Re: **Comments on Revised October 2021 CCP update for MMD Permit No. SF002RE,
LAC Minerals (USA) LLC Cunningham Hill Mine**

At your request I have reviewed the Revised 2021 Closure/Closeout Plan update for Mining and Minerals Division (MMD) Permit No. SF002RE, LAC Minerals (USA) LLC Cunningham Hill Mine (“CHM CCP”). The following comments have been developed to address concerns raised by Friends of Santa Fe County (FOSFC) and are based on more than 40 years of professional experience in addressing mining environmental impacts including 25 years of involvement in the implementation of the New Mexico Mining Act (NMMA) and the New Mexico Water Quality Act (NMWQA) at hardrock mines in NM.

Figures 1 and 2. Graphs of POINT PRECIPITATION FREQUENCY ESTIMATES, NOAA Atlas 14, Volume 1, Version 5 GOLDEN Station ID: 29-3592 Location name: Sandia Park, New Mexico, USA*

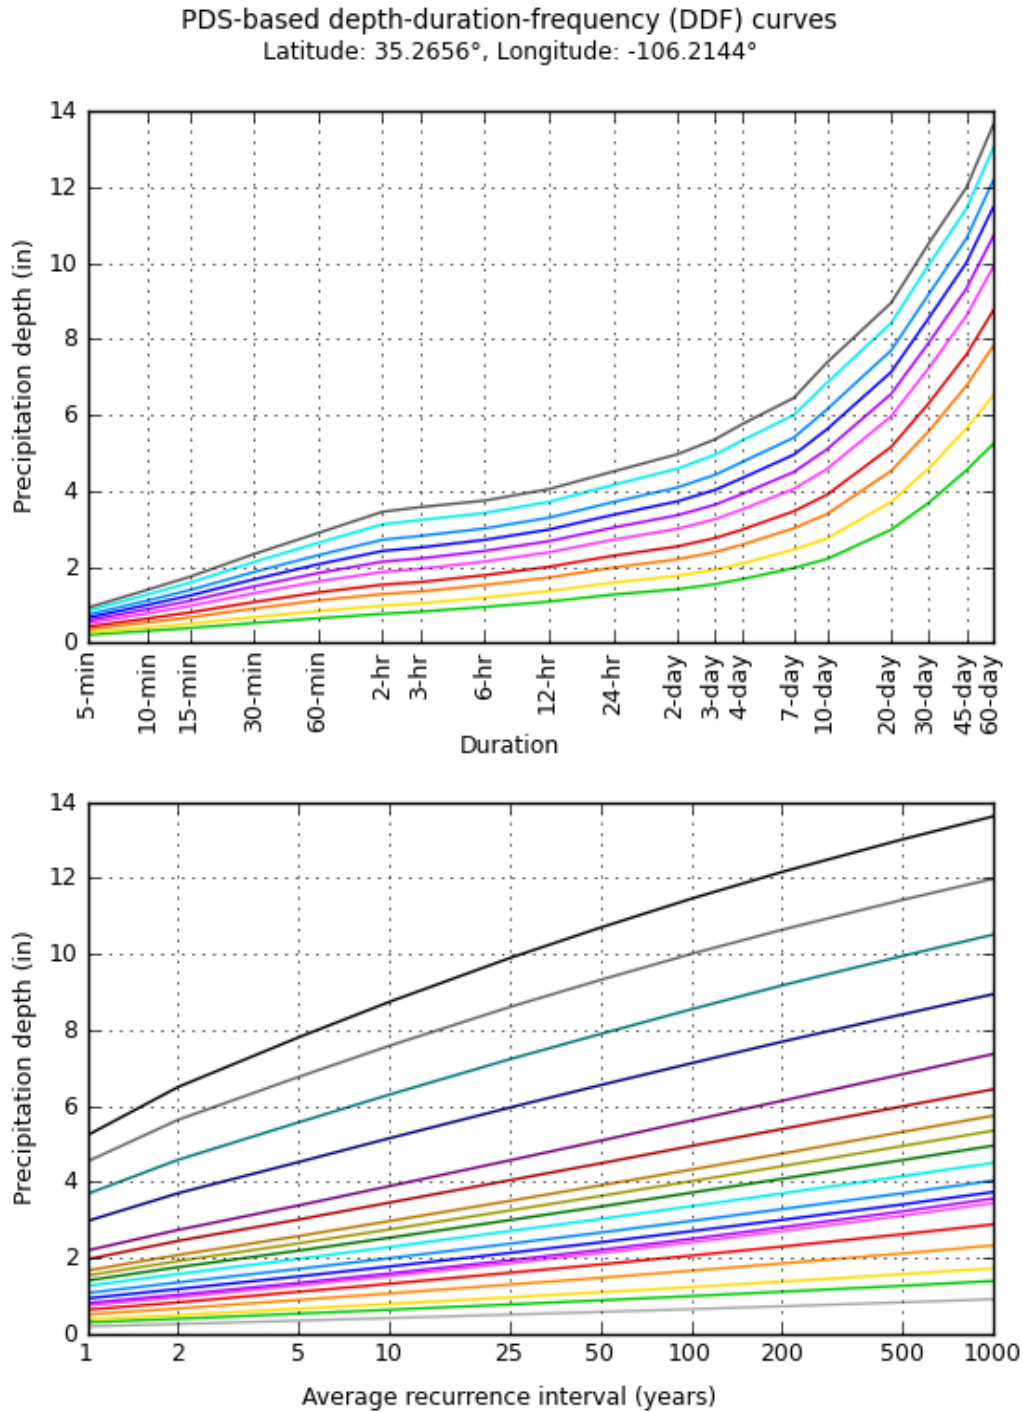
The National Weather Service provides information for specific weather stations including the Golden station referenced in the CHM CCP.⁵ As shown in Table 1 and Figures 1 and 2, the expected precipitation from a 1 in 100 year 24-hr storm event is estimated at 3.37 inches whereas a 1 in 1,000 year 24-hr event is estimated at 4.51 inches. Precipitation from a 1 in 100-year wet period of 30-days is estimated at 8.55 inches whereas a 1 in 1,000 year 30-day event is estimated at 10.5 inches. As has been experienced over the past decade⁶, 1 in 100 year 24-hr storm events are without question becoming more frequent, and 1 in 1,000-year events have occurred in the recent past and are equally if not more likely to occur in the future. This past 2022 Monsoon's precipitation amount was the second wettest in the 25-year period of record kept by Santa Fe County as shown in Figure 3.

Recommendations: The CHM CHP should be revised to recognize and address how climate is expected to be affected by climate change. The agencies should take into consideration the potential for more frequent intense storm events and wet years in their consideration as to the design, construction, maintenance and replacement of engineered covers and stormwater controls features as discussed later in these comments. Additionally, any models or other information that has been produced on behalf of LAC should be based on actual daily data and not average data which significantly compromises such efforts.

Table 4.

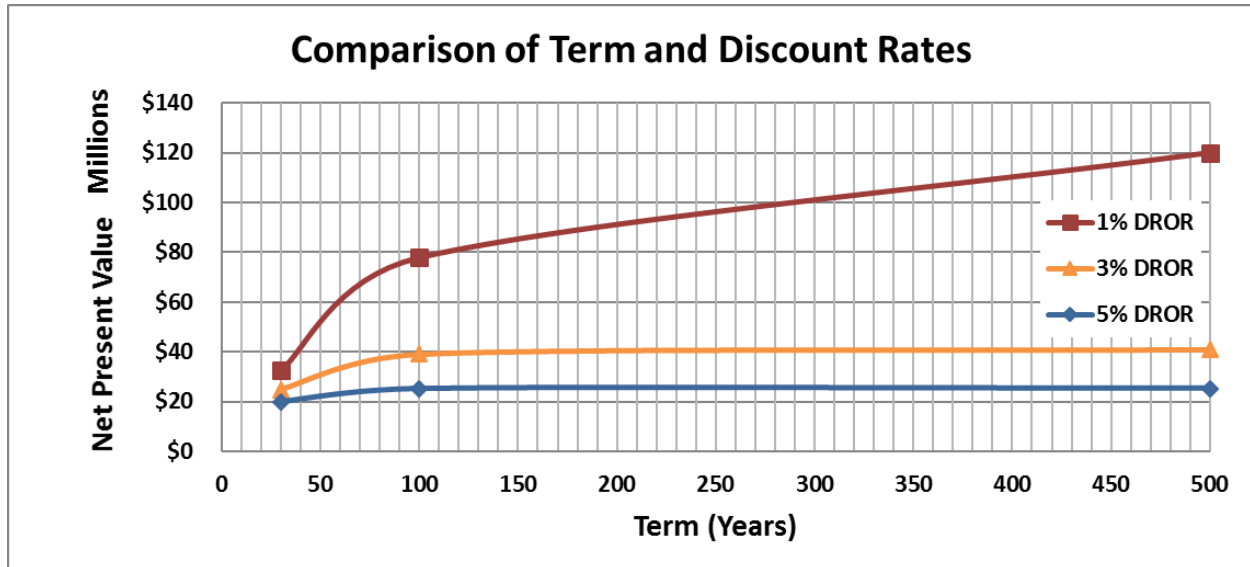
In particular the requirement from NMED to consider long-term costs for activities for 100 years is significant in that the use of that time period is intended to address long-term costs that could actually occur over hundreds, thousands and even tens of thousands of years into the future if present circumstances were to be applied. The recognition that the CHM is not a walk-away proposition is important in that it signifies that in order to ensure that the liability for conducting the necessary future monitoring, maintenance and water treatment tasks does not ultimately become a public/taxpayer liability, a cash or equivalent trust fund based on conservative fiscal assumptions relative to financial assurance must be established. This means that in addition to ensuring the cost estimate is accurate, the estimate should also be performed assuming a longer time period such as 500-years, and a using a conservative assumption as to future inflation and interest, and assume a low net discount rate, such as 1%. How this approach affects the amount of financial assurance is shown in Table 4.

Depending on the Discounted Rate of Return (DROR), which is the rate of interest received on funds invested minus the inflation rate, the impact on the amount of funds estimated is significant. For a 100-year period, using this example, a 5% DROR would result in a Net Present Value (NPV) being calculated of approximately \$25M, whereas using a 3% DROR would result in a NPV of approximately \$38M, and a 1% DROR would result in a NPV of approximately \$75M. It should be noted that currently, with inflation exceeding the interest rate obtainable on typical investment funds appropriate for financial assurance, the DROR would be negative resulting in an even larger amount of financial assurance being necessary than that calculated for the 1% case.

The impact of using a 500-year period is also demonstrated in Table 4. If a 5% DROR is used the result would be to add less than a percent to the NPV. If 3% is used the result would be to increase the amount from approximately \$38M to \$41M. However, if a conservative rate of 1% is used the NPV increases from approximately \$75M if 100 years is used to approximately \$120M if 500 years is used.
